AMENDMENT OF SOLICITATION/MODIFICATION OF CONTRACT			1. CONTRACT ID CODE	PAGE OF PAGES
2. AMENDMENT/MODIFICATION NO. 0004	3. EFFECTIVE DATE 28-Dec-2008	4. REQUISITION/PURCHASE REQ. NO.		5. PROJECT NO.(If applicable) 1 99

14. DESCRIPTION OF AMENDMENT/MODIFICATION (Organized by UCF section headings, including solicitation/contract subject matter where feasible.) ANA TRAINING RANGE COMPLEX, HEART, AFGHANISTAN THE PURPOSE OF THIS AMENDMENT TO SOLICITATION W917PM-09-R-0004 IS TO MAKE CHANGES ON SECTION 00010, SECTION 00110, SECTION 00120, SECTION 01010, SECTION 01015 AND INCORPORATE THE ANSWERS FROM THE CONTRACTOR'S QUESTIONS. THE TECHNICAL AND PRICE PROPOSAL REVISED DUE DATE OF 10 JANUARY 2009 IS HEREBY EXTENDED. THE NEW PROPOSAL DUE DATE IS 24 JANUARY 2009. ALL OTHER TERMS AND CONDITIONS REMAIN UNCHANGED. Except as provided herein, all terms and conditions of the document referenced in Item 9A or 10A, as heretofore changed, remains unchanged and in full force and effect.				
15A. NAME AND TITLE OF SIGNER (Type or print)		16A. NAME AND TITLE OF CONTRACTING OFFICER (Type or print)		
		TEL:	EMAIL:	
15B. CONTRACTOR/OFFEROR _____ (Signature of person authorized to sign)	15C. DATE SIGNED	1

FIRST FLOOR PLAN
SCALE : N.T.S.

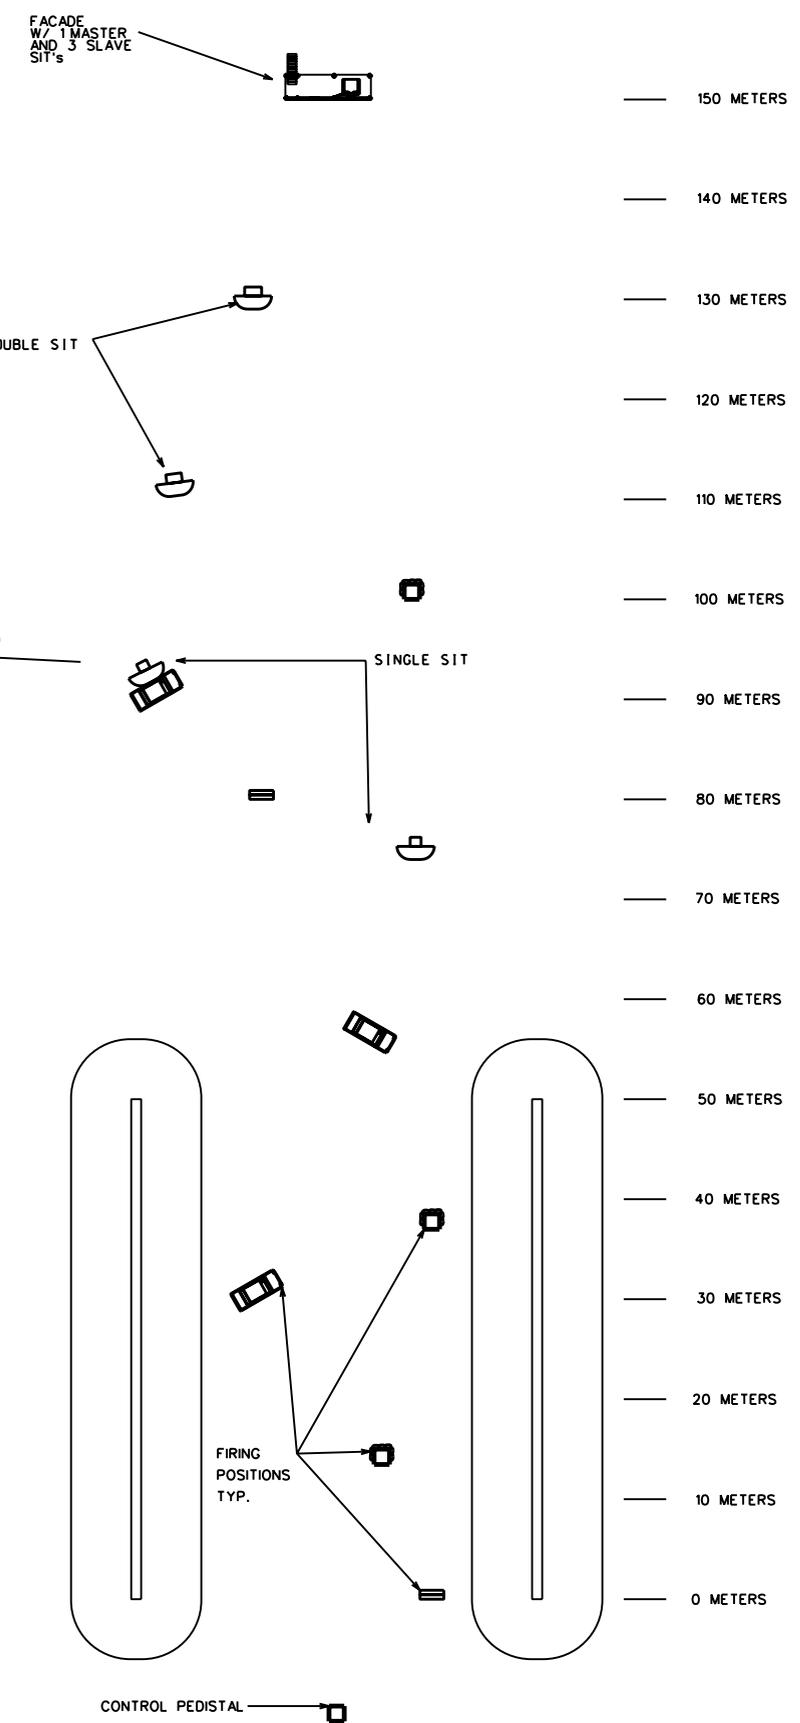
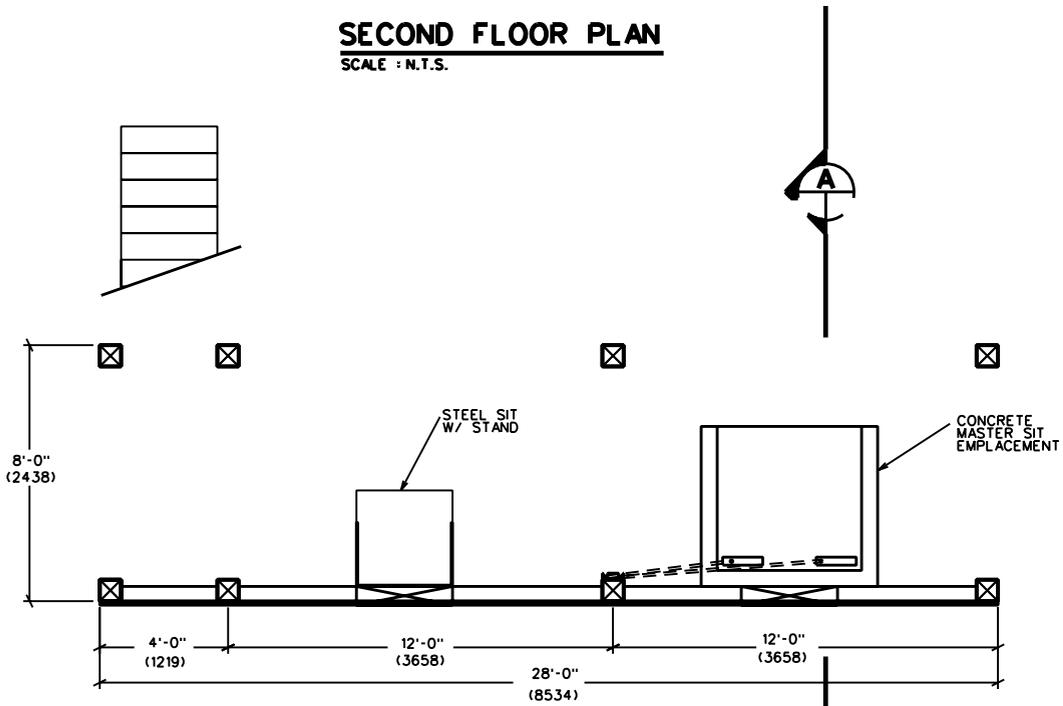
Note: The construction of this building for Station 3 of Urban Combat Area shall be considered as an option.
